RESPONSE TO REQUEST FOR ADDITIONAL INFORMATION

APR1400 Design Certification

RAI No.: 343-8420
SRP Section: 12.02 - Radiation Sources
Application Section: 12.2
Date of RAI Issue: 12/22/2015

Question No. 12.02-22

Figure 1. Tank Levels of the Holdup Tank.

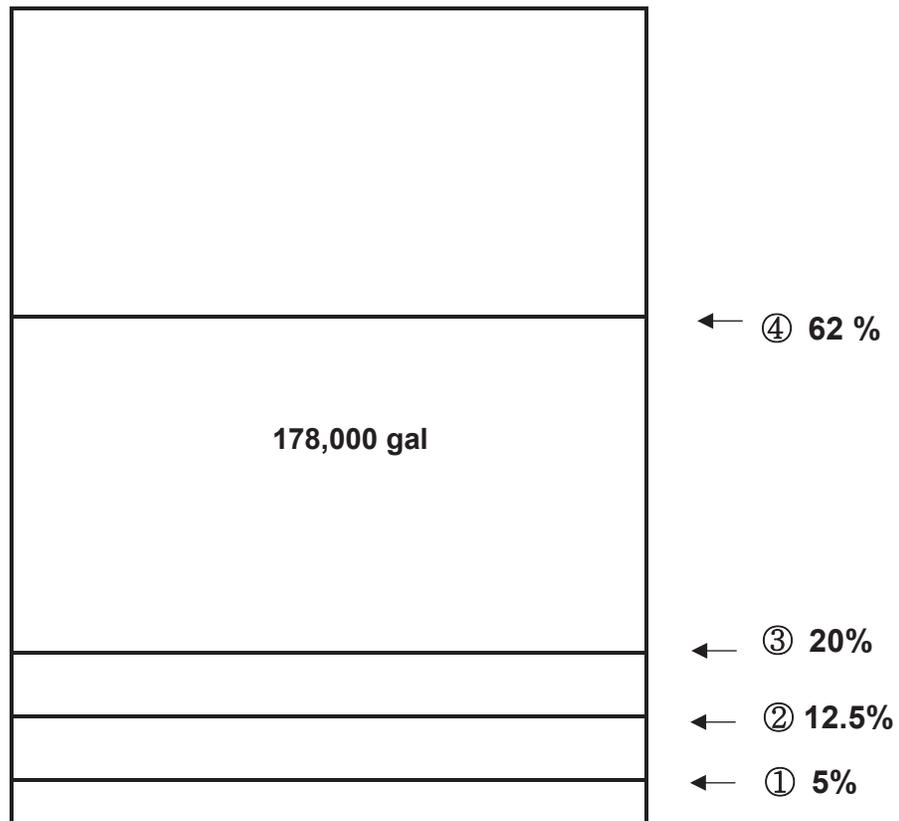
1. In the response to Question 12.02-2 and 12.02-3, the applicant provided source term information for tanks containing liquid radioactive material. The source term information indicated that the source terms used for radiation shielding and zoning for many of the tanks was based on the tanks being filled to only a small fraction of the tanks' total volume. Since the SRP specifies that zoning (and therefore shielding) should be based on

the maximum dose rate, it isn't appropriate that the maximum designed dose rates would be based on a fraction of the total tank volume. Examples include the following:

- a. Holdup Tank – 12.5% full (See response to Question 12.2-3, FSAR Table 12.2-25 markup).
- b. Boric Acid Storage Tank - 50% full (See response to Question 12.2-3, FSAR Table 12.2-25 markup).
- c. Reactor Makeup Water Tank – 80% full (See response to Question 12.2-3, FSAR Table 12.2-25 markup).
- d. Reactor Drain Tank – 62% full (See response to Question 12.02-2, FSAR Table 12.2-25 markup)
- e. Equipment Drain Tank – 37% full (See response to Question 12.02-2, FSAR Table 12.2-28 markup)
- f. IRWST – 75% full (See response to Question 12.02-2, FSAR Table 12.2-25 markup)

Please revise the radiation source terms, shielding, and zoning for these tanks and all other liquid containing tanks in the FSAR (which are not currently based on the tanks being at or very near full capacity), so that they are based on tanks filled to their full capacity. The revised tank source terms should assume the additional liquid volume comes from input pathways that would result in the maximum source term for shielding and zoning as indicated in SRP 12.2 (i.e. the original radionuclide concentrations should not be decreasing with the increased liquid volume, except for additional decay time which may be appropriate, unless appropriate justification is provided for other assumptions resulting in diminished source term concentrations). The revisions should also consider the effects of source term changes made as part of responses to other Section 12.2 RAIs.

- ① Low Level Fraction (5%) : It is equal to the low level alarm setpoint which is based on the minimum tank volume required to supply the minimum NPSH to the holdup pumps with instrument channel accuracy.

③ High Level Fraction (20%) : It is equal to the high level alarm setpoint which is set to accommodate water volume for one cold shutdown and subsequent startup, and indicates that tank processing needs to be initiated. This level is the highest level for normal power operation from the beginning of fuel cycle except the shutdown operation.

③~④ Additional inflow volume (42%) from shutdown operation.

- 1) To calculate HUT vapor activity, the low level fraction (5%) is used in order to maximize vapor space activities.
- 2) To calculate HUT liquid activity, the water level (62%) is used in order to maximize liquid space activities. This level (62%) includes the normal power operation volume (20%) and additional inflow volume (42%) from shutdown, refueling operation and startup operations for shutdown operation.

- ② The shielding calculation of the Holdup Tank includes the use of liquid and vapor phase design basis source terms at 0.25% failed fuel fraction. The liquid phase volume uses 12.5% of the total tank volume, but the source term includes the radioactivity for the maximum water level 62%, concentrated to the 12.5% liquid volume. The shielding calculation also includes the vapor phase radioactivity at 87.5% tank volume, which is

Please note that the 12.5% volume is an artificial assumption to adjust liquid and vapor phase volumes to 100% in order to maximize the vapor phase volume and source term. Even though that the liquid volume can be as high as 62%, the combined source terms for shielding calculation are based on a liquid volume of 12.5% and a vapor phase volume of 87.5% in order to make the conservative shielding source terms.

Figure 6. Tank Levels of the In-containment Refueling Water Storage Tank

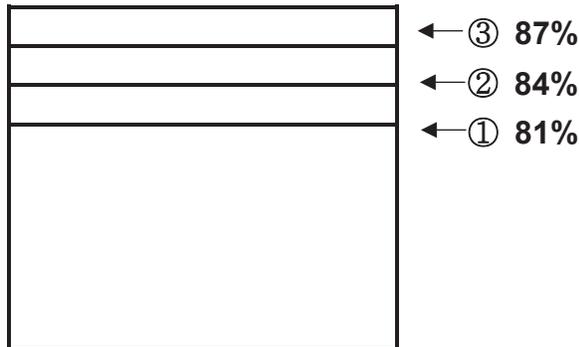
- e. The IRWST volume provided in the revised FSAR Table 12.2-25 is different from the volume provided in the new FSAR Table 12.2-28. Please correct this discrepancy.

- ① Low Level Fraction (81 %) : It is equal to the low level alarm setpoint which is based on the required water volume for providing adequate ESF pumps operation during accident operation.
- ③ High Level Fraction (87 %) : It is equal to the high level alarm setpoint which is based on the water level to prevent the reactor vessel breach from flooding caused by inadvertent operation of the cavity flooding system during normal operation.

- ② Midpoint of ① and ③ : The middle (84%) of low level fraction (81 %) and high level fraction (87%) is assumed as liquid volume and rest of this is assumed as vapor volume. The liquid and vapor source terms are identified at this level.

- ① To calculate IRWST vapor activity, the low level fraction (81 %) is used in order to maximize vapor space activity.
- ③ To calculate IRWST liquid activity, the high level fraction (87 %) is used to maximize liquid space activity.

Since the IRWST is located inside the containment and surrounded with the walls which have sufficient wall thickness for shielding, it is expected not to cause any significant impact on the plant structure design. Radiation zoning inside IRWST was determined based on the zoning for SFP since the source term of SFP is comparable to that of IRWST.
